SIMOCRANE

Basic Technology V2.0 SP2

Main Changes

Siemens Cranes
Product Management
December 2010, Germany

Communication between PLC / Simotion / Sinamics

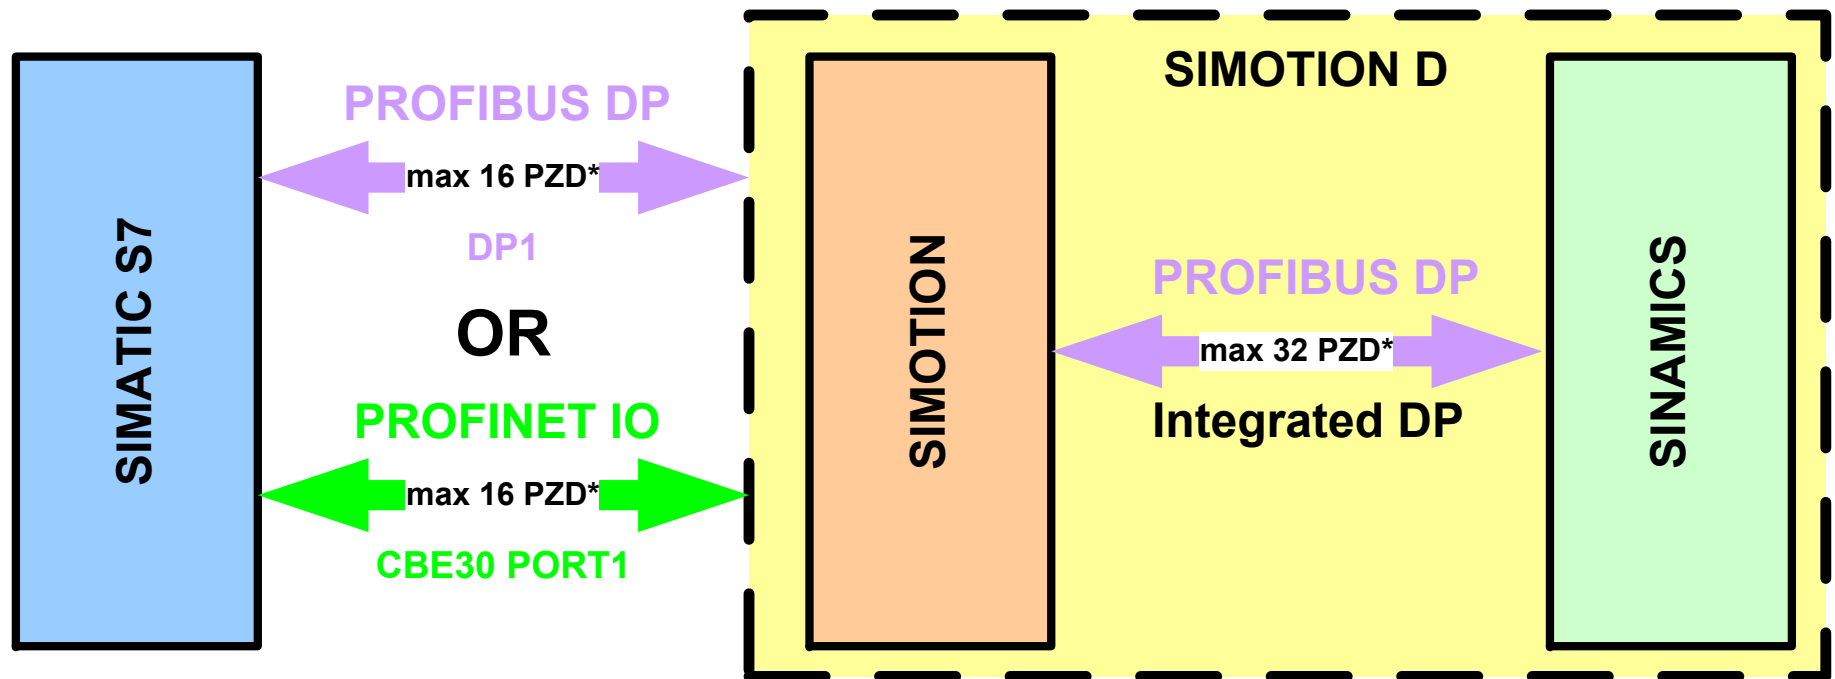
Communication between PLC / Simotion / Sinamics OLD

NEW

*for each drive

Example: Changeover Trolley to Boom(Appl_STW1 Bit15)

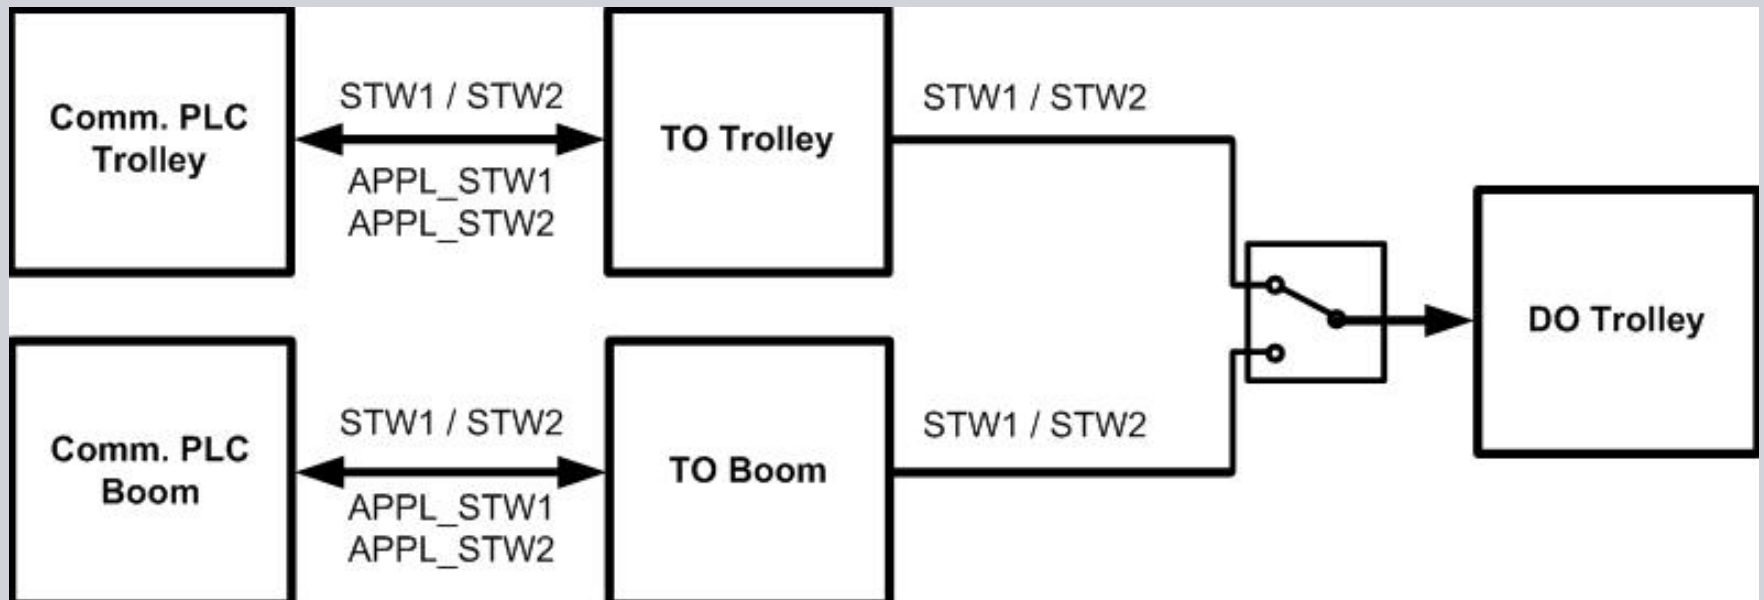
NEW

| 1. Pulse disable: | STW1 Bit 3 | = FALSE |
| 2. Deselect “boChangeTechnologyObject”: | Appl_STW2 Bit 15 | = FALSE |
| 3. Check Trolley drive: | ZSW1 Bit 9 | = FALSE |

| 4. Select “boChangeTechnologyObject”: | Appl_STW2 Bit 15 | = TRUE |
| 5. Check Boom drive: | ZSW1 Bit 9 | = TRUE |
| 6. Pulse enable: | STW1 Bit 3 | = TRUE |

Changed DCC-Blocks (Chapter 4.2)

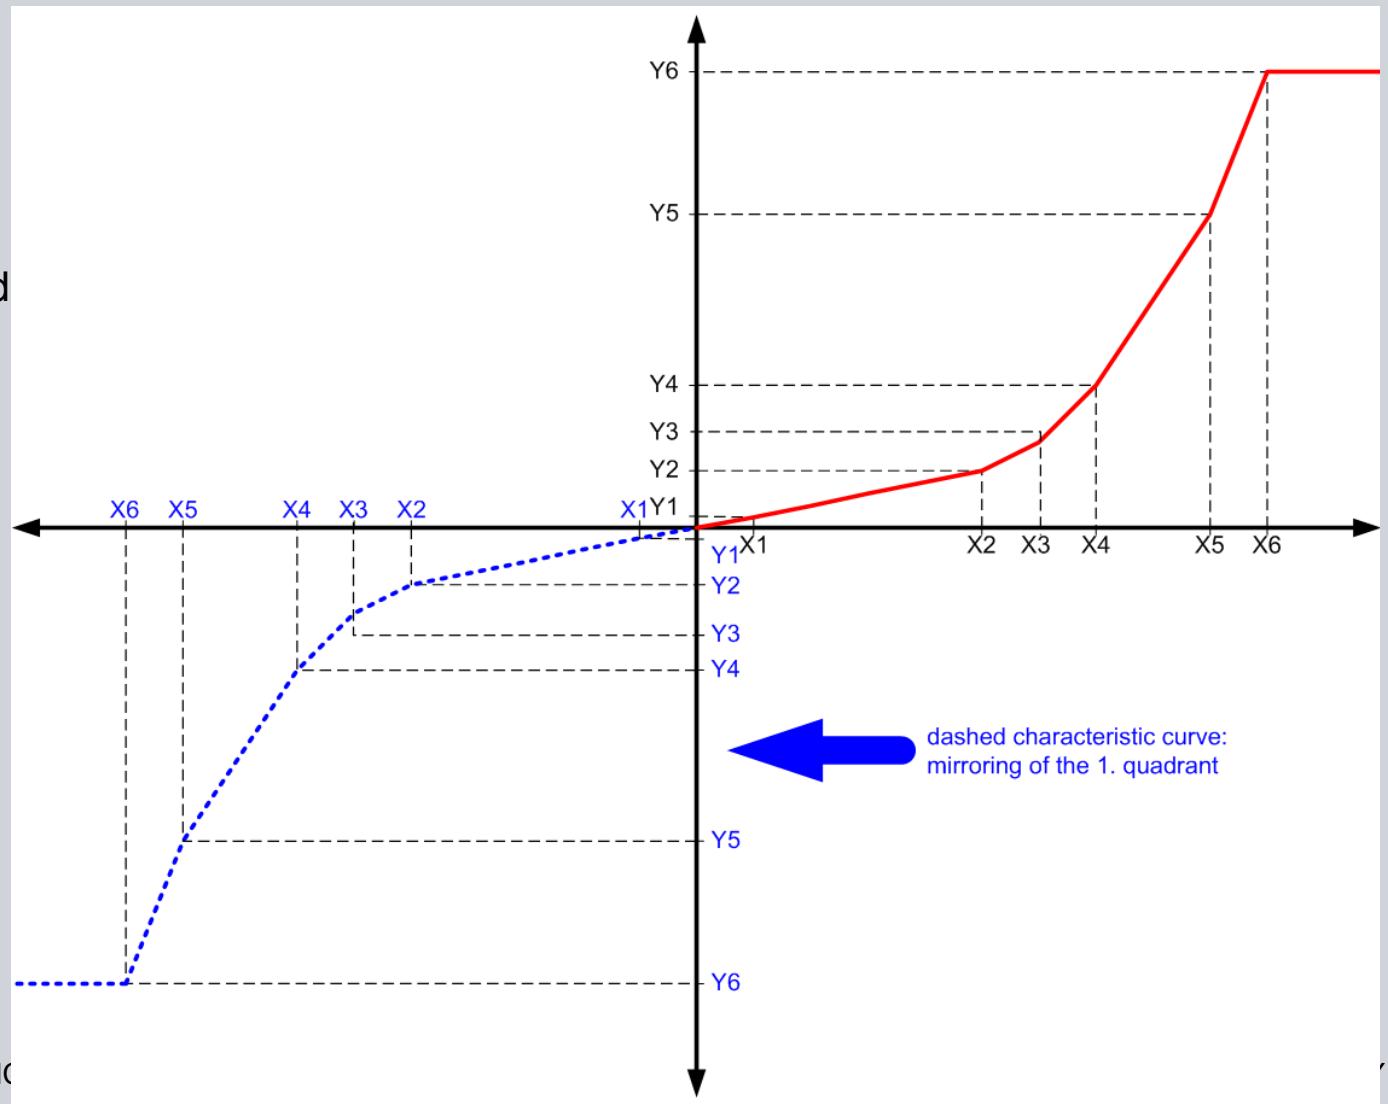
Old

DCC_MasterSwitch

DCC_SlackRopeControl

DCC_CurrentEqualControl

DCC_ContLoadMeasurement

DCC_OverSpeed

New

DCC_MasterSwitch_1

DCC_SlackRopeControl_1

DCC_CurrentEqualControl_1

DCC_ContLoadMeasurement_1

DCC_OverSpeed

DCC_SlackRopeControl_1

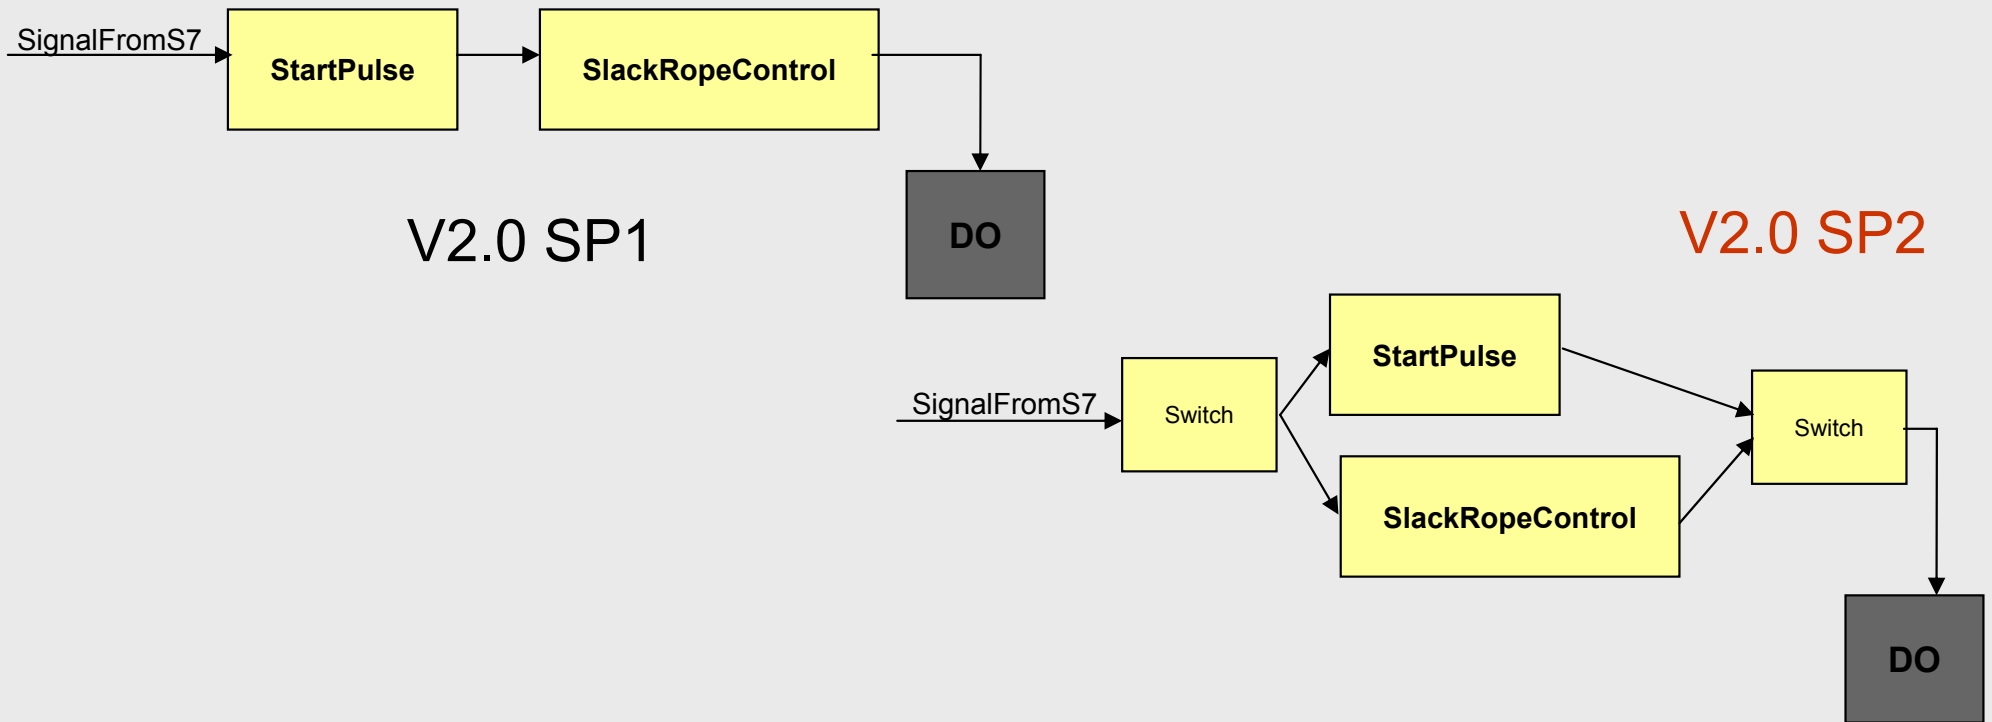
Three methods for slack rope control

1. Closed-loop control using a setpoint value (P controller)
 - A filter is added to avoid setpoint jump
 2. Closed-loop control using a saved characteristic (polygon)
 - 20 points polygon was changed to 6 point polygon
 - A filter is added to avoid setpoint jump
 3. Specifying a torque limit from S7
 - Enabled by "boEnableTorqueLimit"
 - TorqueLimit from S7 (e.g. PZD 14)
-
- Easy-Closing function
 - Enabled by "boEnableEasyClosing"
 - An additional 6-point polygon for evaluating closing gear current
 - Additional hoisting as function of closing gear current
 - Adaptation to several types of material
 - Enabled by "boEnableMaterialFactor"
 - A multiplier with the "rMaterialFactor" is added
 - MaterialFactor from S7 (e.g. PZD13)
 - Remove input "rInVelocitySetpoint"
 - Refer to DCC_CurrentEqualControl_1

DCC_OverSpeed with extension

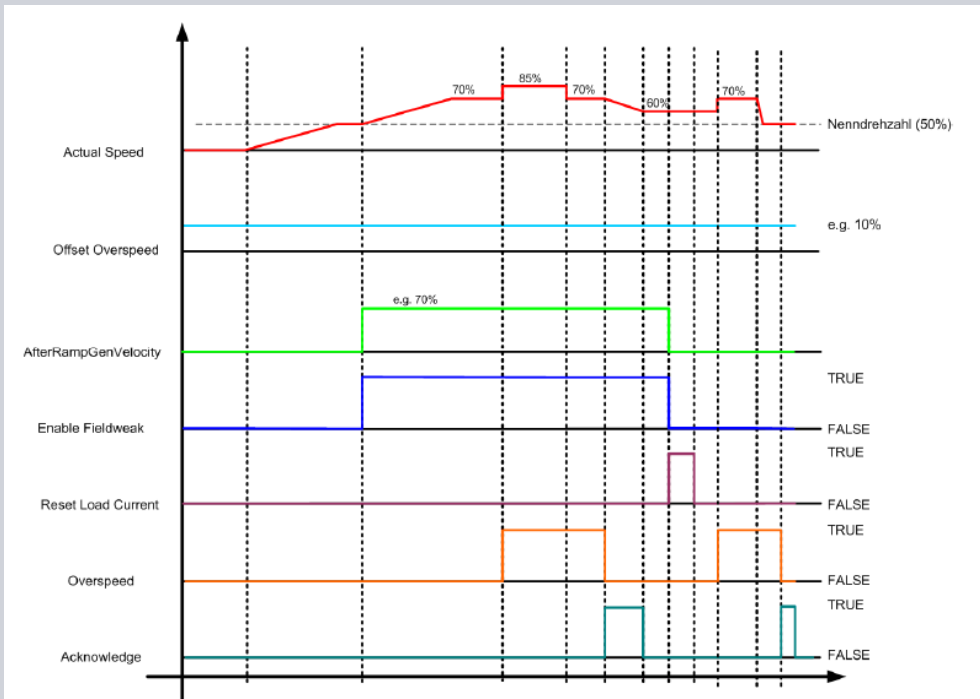
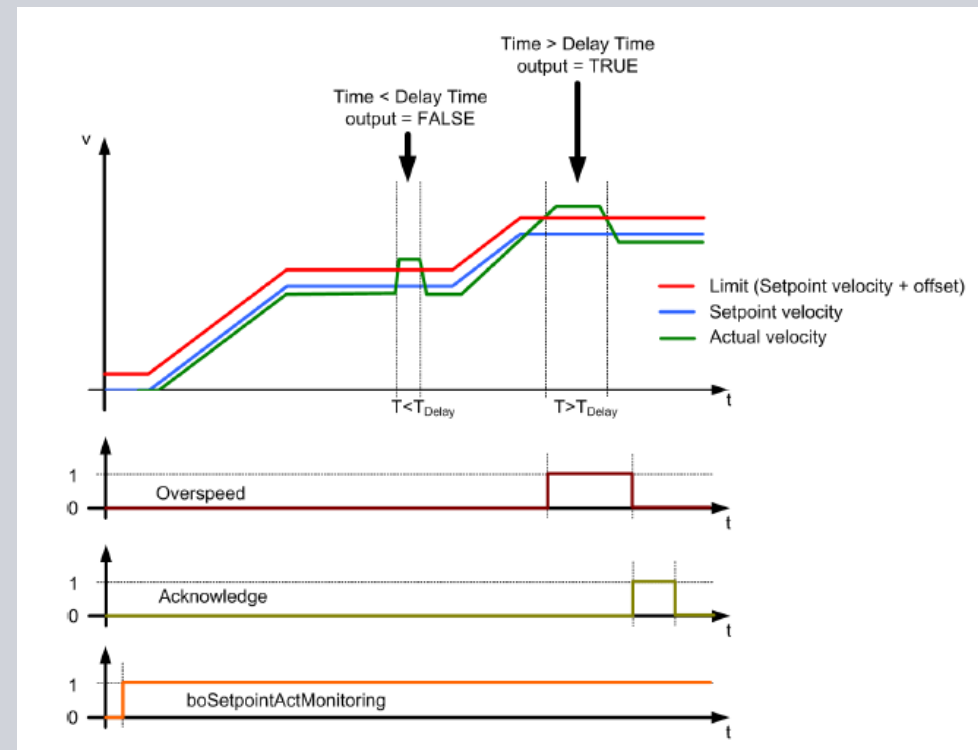
"boSetpointActualMonitoring" = False

"boSetpointActualMonitoring" = TRUE

Simplify the parameter-setting of reference value (Simotion & Sinamics p2000)

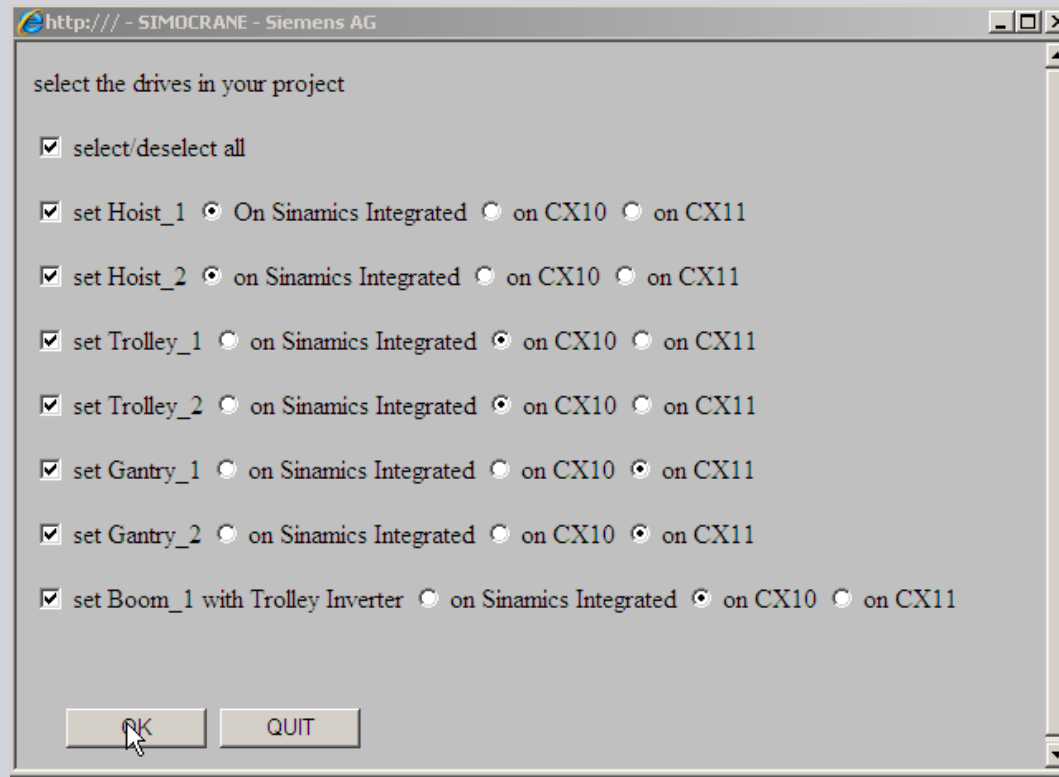
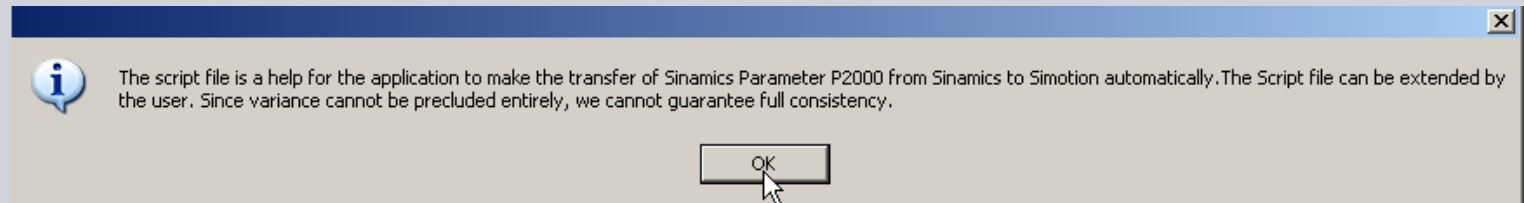
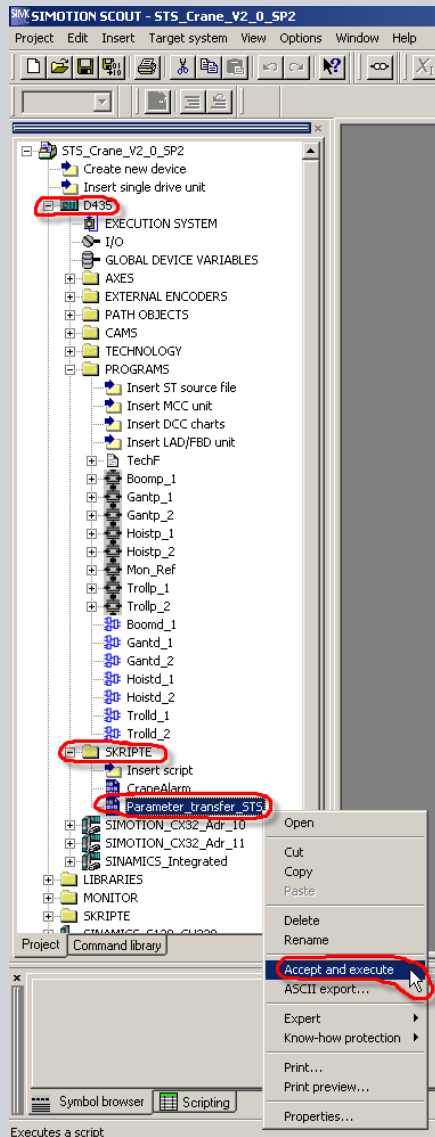
S7	Simotion	Sinamics
Ref. Speed [rev/min]	Ref. Speed [rev/min]	Ref. Speed [rev/min]

via script automatical setting of p2000 to Simotion

each Crane Type has its script-file for Crane Alarm and Parameter setting
